STAFF REVIEW AND RECOMMENDATIONS
PUBLIC HEARING
SEPTEMBER 30, 2020

PRELIMINARY PLAT: MOSSY HAVEN 2
LEGAL DESCRIPTION: SEC 20, T17N, R01W, SEWARD MERIDIAN AK
PETITIONERS: CHARLIE & DELISA RENIDEO
SURVEYOR/ENGINEER: KEYSTONE SURVEYING/PIONEER ENGINEERING INC.
ACRES: 8.62 ± PARCELS: 4
REVIEWED BY: AMY OTTO-BUCHANAN CASE #: 2020-121

**STAFF REVIEW AND RECOMMENDATIONS
PUBLIC HEARING
SEPTEMBER 30, 2020**

ABBREVIATED PLAT: VALLEY WAY
LEGAL DESCRIPTION: SEC 33, T18N, R2E, SEWARD MERIDIAN, AK
PETITIONER: CLINTON MELIN FOR CM MECHANICAL, INC. AND
GORDON & SIMONE FLETCHER
SURVEYOR/ENGINEER: HANSON LAND SOLUTIONS
ACRES: 0.53 PARCELS: 2
REVIEWED BY: PEGGY HORTON CASE: 2020-130

**MOSSY HAVEN 2
TEST HOLE MAP**

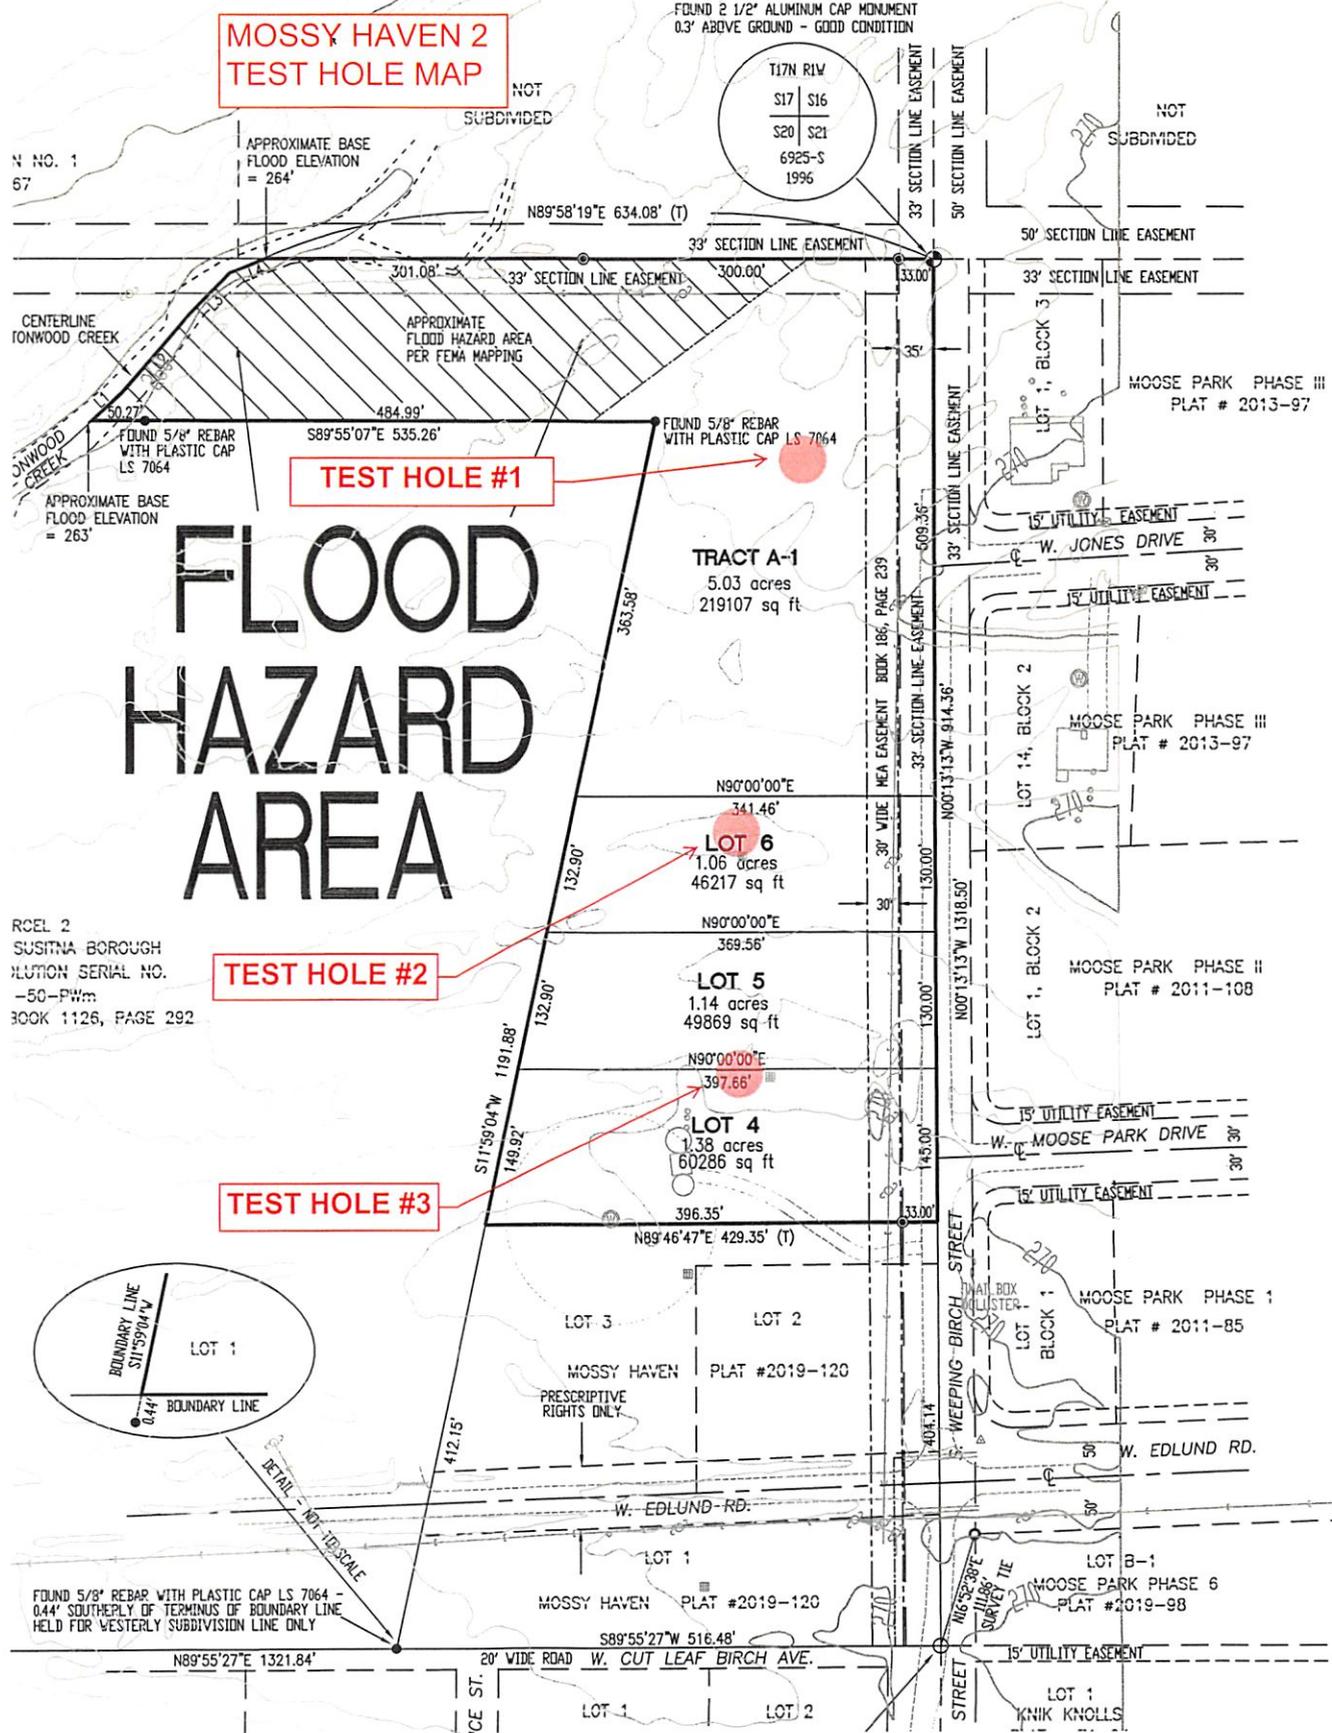
Comments: Department of Public Works Operations & Maintenance (**Exhibit C**) notes created useable areas for Lots 5 & 6 and Tract A-1 will need to be shown (see **Recommendation #5**). S. Weeping Birch Street on the north side of W. Edlund Road is classified as a Collector. ADOT&PF has plans to connect S. Weeping Birch Street to S. KGB Road. Direct residential access to S. Weeping Birch Street should be limited per SCM A06.1 (see **Recommendation #6**, which recommends a common access point at the common lot line of Lot 4 and Lot 5). Staff does not recommend limiting access to Tract A-1 to the common lot line with Lot 6, as Tract A-1 may be further subdivided in the future. This will allow for a common access driveway directly across from W. Jones Drive in the future.

Show where useable area will be created on lots 5 & 6 and Tract A-1.

5. A soils report was submitted, pursuant to MSB 43.20.281(A)(1)(i)(i). Lots 5 & 6 and Tract A-1 will require fill or regrading to meet the requirement of 10,000 sf of contiguous useable septic area.
